City of Portland, Maine - Building or Use Permit Application 389 Congress Street, 04101, Tel: (207) 874-8703, FAX: 874-8716 Location of Construction: Phone: Owner: Permit No: 447 Riverside St. Rice, Edward & Sandra Owner Address: Lessee/Buver's Name: BusinessName: Phone: 878-8577 Rice Glass Co. Permit Issued: Contractor Name: Address: Phone: Caron Signs COST OF WORK: PERMIT FEE: Past Use: Proposed Use: \$38.60 FIRE DEPT. □ Approved INSPECTION: Comm Same ☐ Denied Use Group: Type: Zone: CBL: 313-D-001 Signature: Signature: Zoning Approval: Proposed Project Description: PEDESTRIAN ACTIVITIES DISTRICT (P.A.D.) Action: Approved Special Zone or Reviews: Approved with Conditions: □ Shoreland Denied Erect Signage (68 Sq Ft) □ Wetland ☐ Flood Zone Signature: Date: □ Subdivision □ Site Plan maj □minor □mm □ Permit Taken By: Date Applied For: Mary Gresik 18 September 1997 **Zoning Appeal** □ Variance This permit application does not preclude the Applicant(s) from meeting applicable State and Federal rules. ☐ Miscellaneous Building permits do not include plumbing, septic or electrical work. ☐ Conditional Use Building permits are void if work is not started within six (6) months of the date of

PROPERTY PLAN

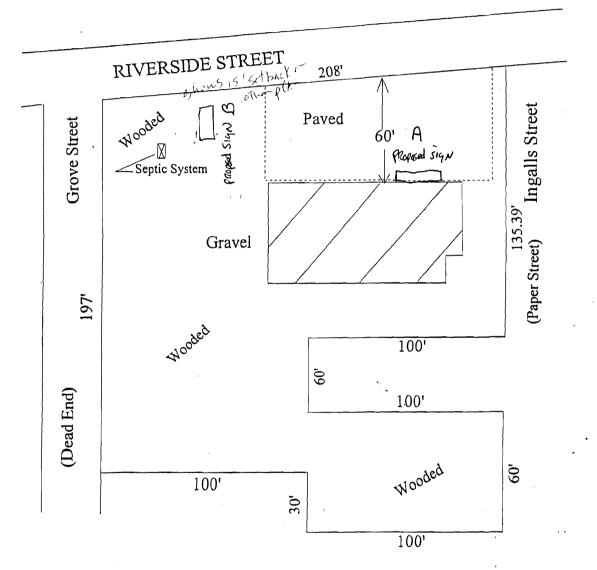
| ADDRESS: 447 Riverside St DATE: 9/23/97 |
|---|
| 9. Other requirements of condition The Bulding Sign Shall be Attached |
| To he building And Shall Not be A roof Sign, foof |
| Signs Are Not allowed |
